CONTRACT CHANGE ORDER MEMORANDUM

TO: DEANNA VILCHECK / JEANNETTE BALDERRAMOS			FILE: E.A. 04 - 0120M4
FROM: JEANNETTE BALDERRAMOS			CO-RTE-PM 04-ALA-80-1.6/2.7
			FED. NO. NO FED AID
CCO#	SUPPLEMENT#:	Category Code:	CONTINGENCY BALANCE (incl. this change)
1	0	AJZZ	\$5,079,361.00
COST: \$250,000.00		INCREASE <input checked="" type="checkbox"/> DECREASE <input type="checkbox"/>	HEADQUARTERS APPROVAL REQUIRED? <input type="checkbox"/> YES <input checked="" type="checkbox"/> NO
SUPPLEMENTAL FUNDS PROVIDED: \$250,000.00		IS THIS REQUEST IN ACCORDANCE WITH ENVIRONMENTAL DOCUMENTS? <input checked="" type="checkbox"/> YES <input type="checkbox"/> NO	
CCO DESCRIPTION: Flagging & Traffic Control			PROJECT DESCRIPTION: CONSTRUCT BRIDGES AND ROADWAY, AND ELECTRICAL SYSTEM
Original Contract Time:	Time Adj. This Change:	Previously Approved CCO Time Adjustments:	Percentage Time Adjusted: (including this change)
1140 Day(s)	0 Day(s)	0 Day(s)	0 %

CCO DESCRIPTION: Dispute Review Board (Caltrans Portion)		PROJECT DESCRIPTION: CONSTRUCT BRIDGES AND ROADWAY, AND ELECTRICAL SYSTEM		
Original Contract Time: 1140 Day(s)	Time Adj. This Change: 0 Day(s)	Previously Approved CCO Time Adjustments: 0 Day(s)	P

CONTRACT CHANGE ORDER NO. 10
SHEET 2 OF 3
04-0120MA

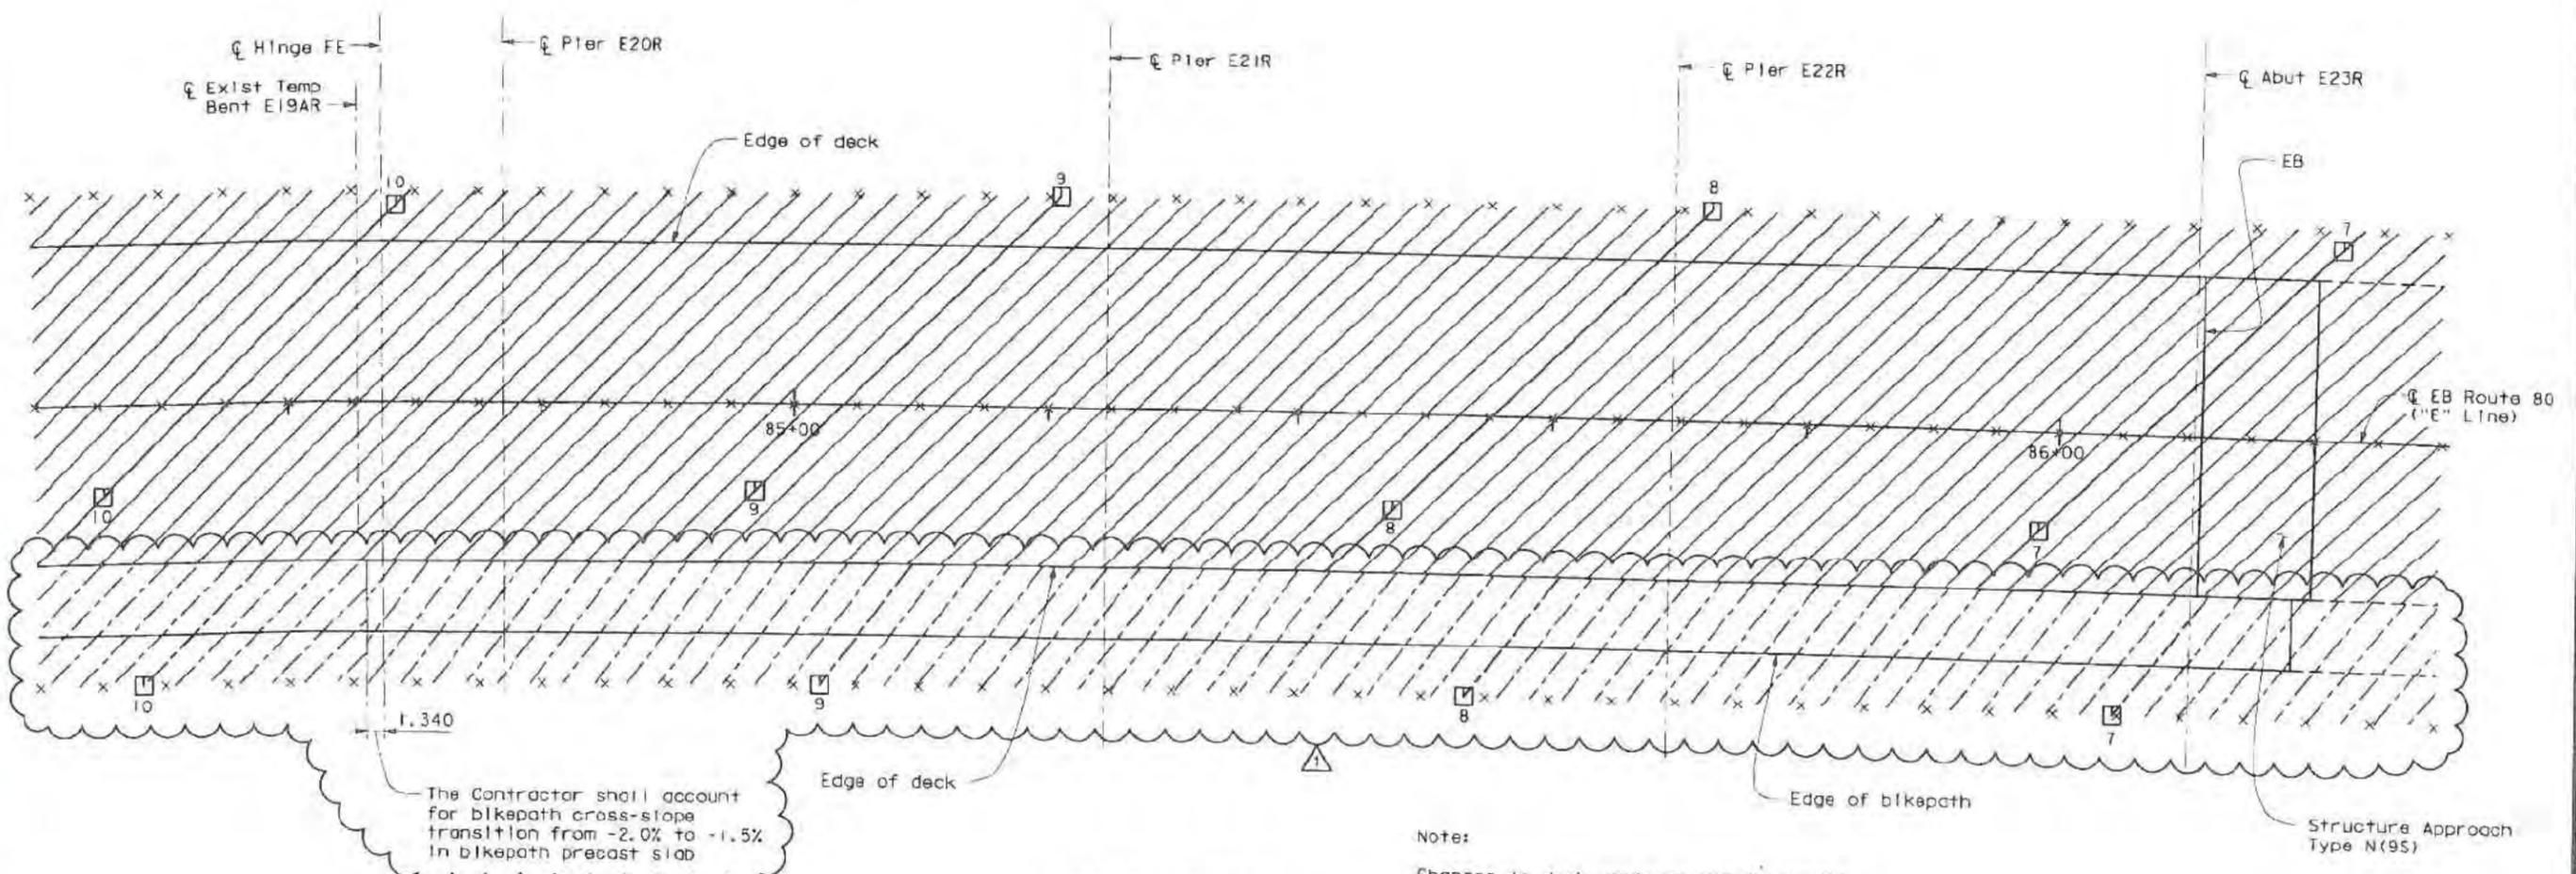
Incorporate the change to the bikepath cross-slope as shown on revised Contract Plan Sheet Nos. 589R1 and 650R1, sheet nos. 2 and 3 of 3 of this contract change order.

Revise the bikepath cross-slope from a 2% to 1.5% to meet American with Disabilities Act (ADA) requirements.

The Office of Structure Design revised the bikepath cross-slope, as shown on revised Contract Plan Sheet Nos. 589R1 and 650R1, from a 2% to 1.5% to comply with a new American for Disability Act requirements

MARK	DATE	DESCRIPTION	BY	CH'D
1	6/7/12	REVISED BIKEPATH CONTOURS	MSC	TWD

2010 STANDARD PLAN B7-1

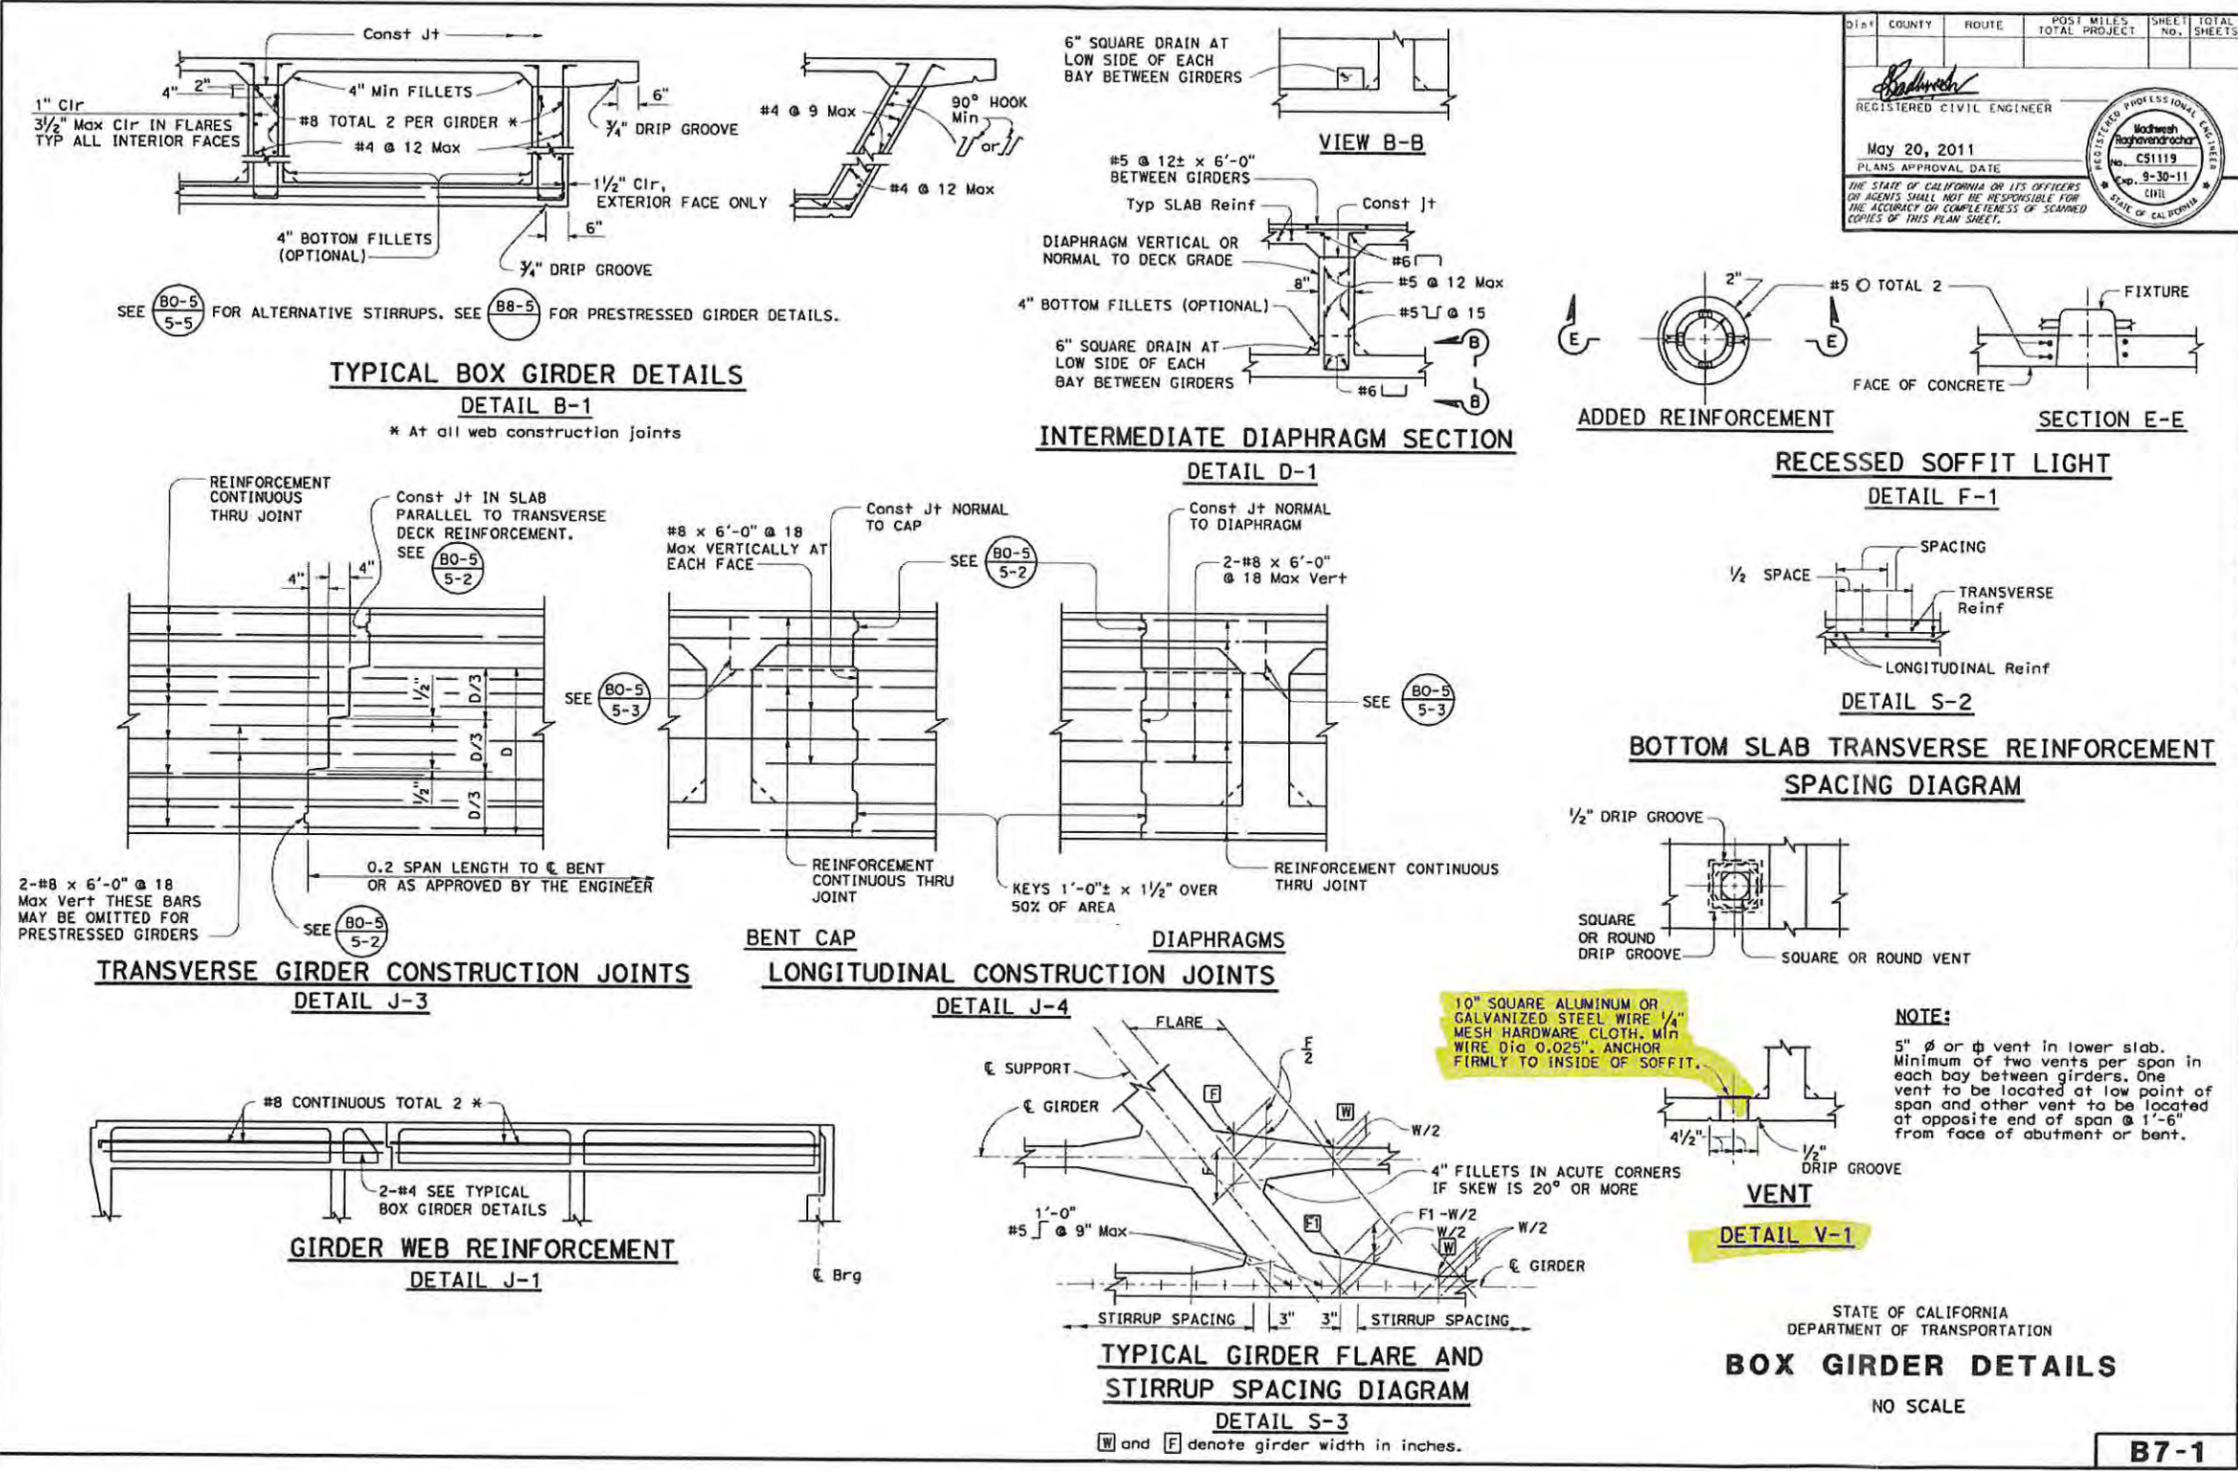
In order to prevent wildfowl nesting, the Contractor shall install bird screens per Detail V-1 as shown on Standard Plan B7-1 (2010 Standard Plans) and other measures as directed by Engineer.

Install bird screens to prevent wildfowl nesting around the new and existing bridge structures within the Oakland Touchdown 2 project limits per Detail V-1 as shown on Standard Plan B7-1 (2010 Standard Plans) and other measures as directed by Engineer.

△	5/8/12	REVISED WORK ACTIVITY No.	GT	MM
MARK	DATE	DESCRIPTIONS	REV	CHK
REVISIONS				
CONTRACT CHANGE ORDER No. <u>019</u>				
SHEET <u>2</u> OF <u>5</u>

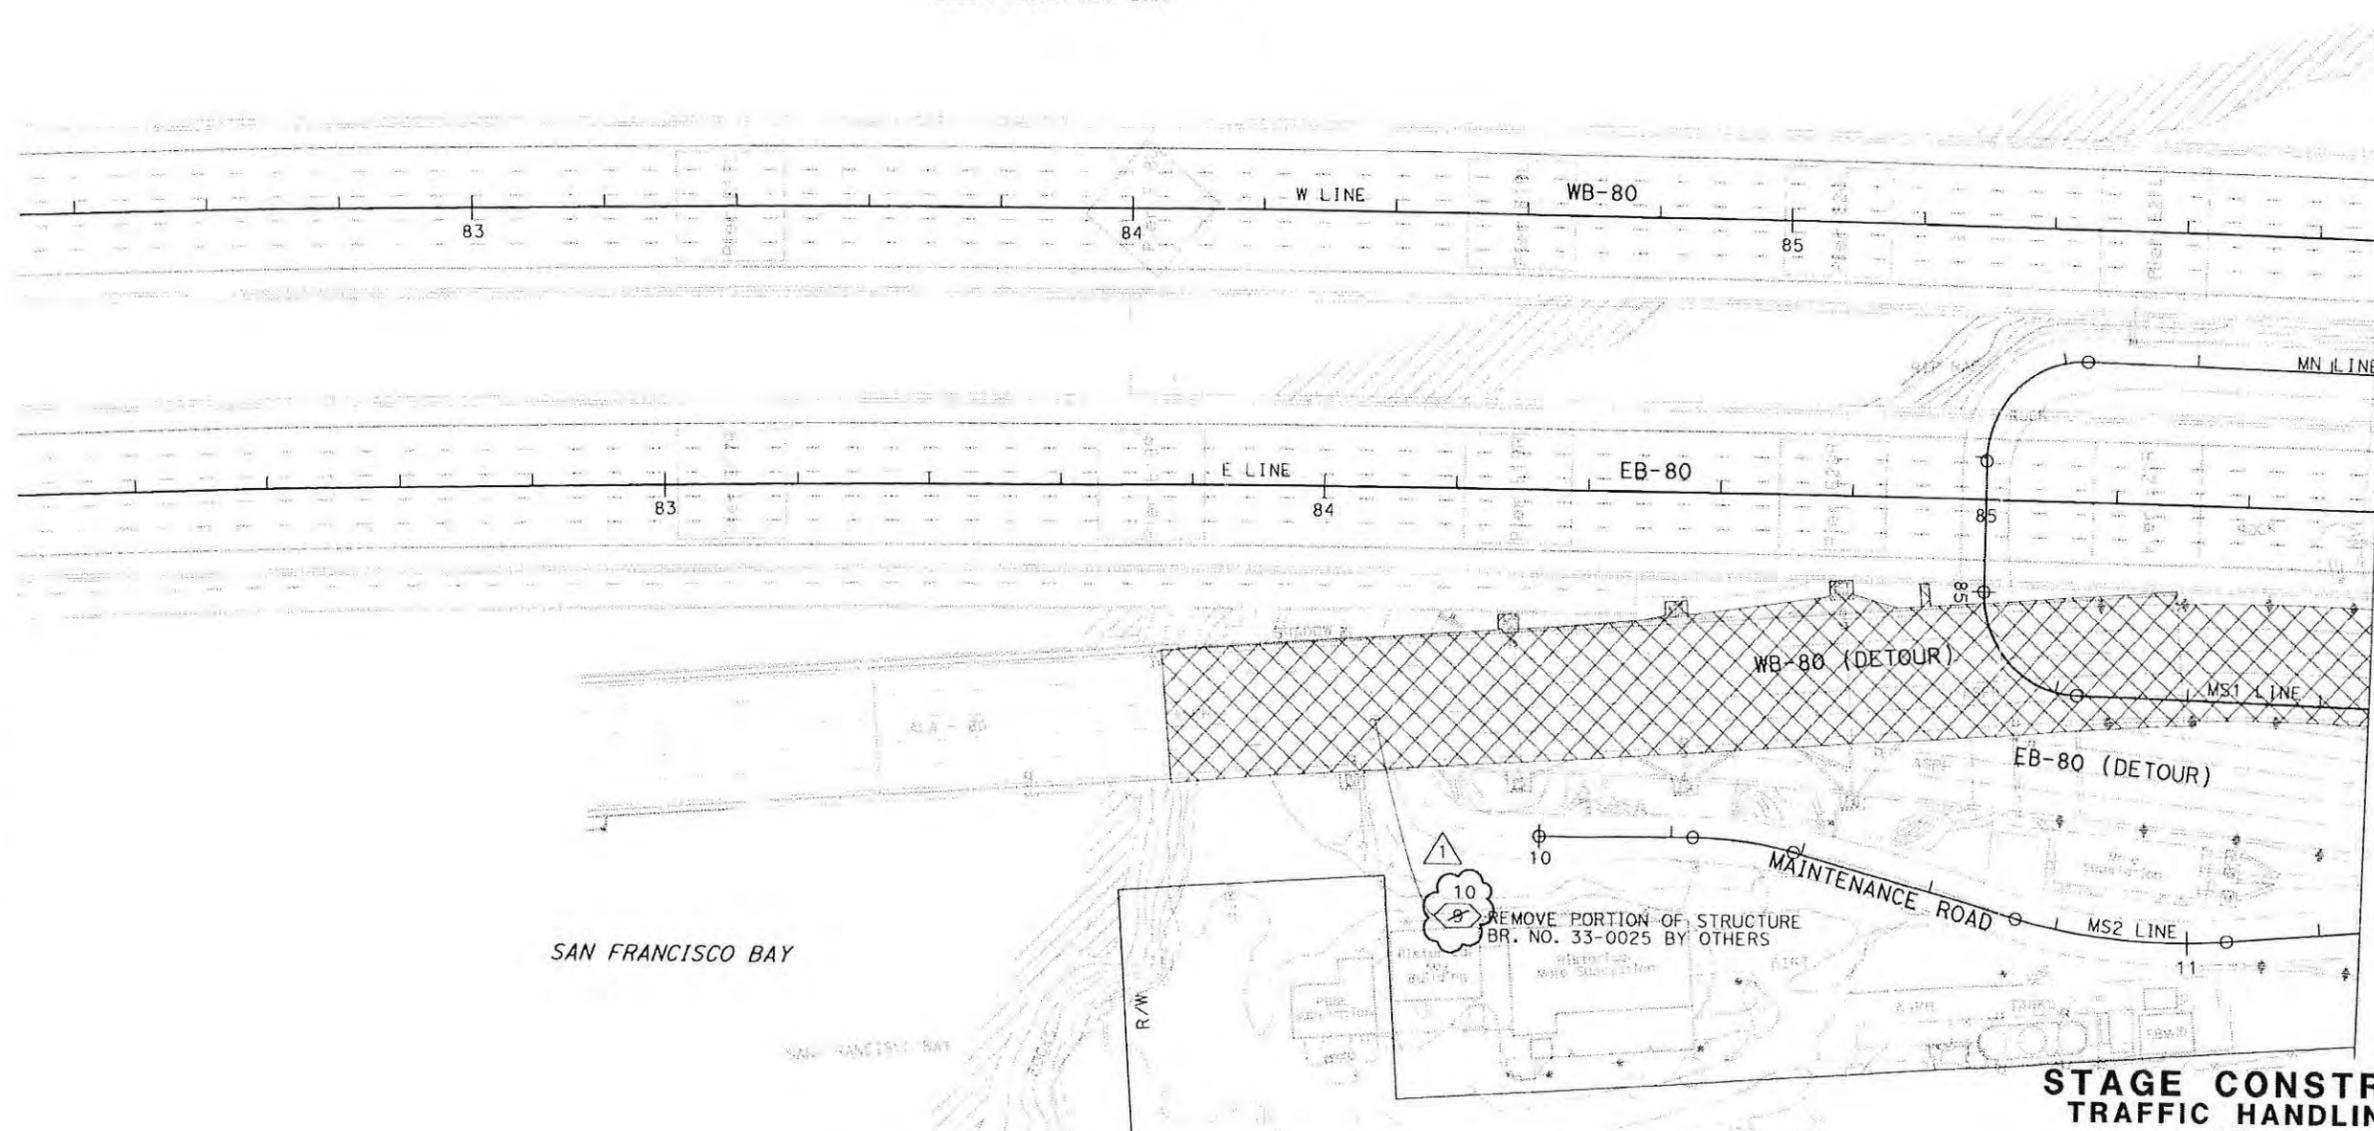
The Stage Construction Work Activity numbering is corrected as shown on sheets 2 through 5 of this change order, contract plan sheets:
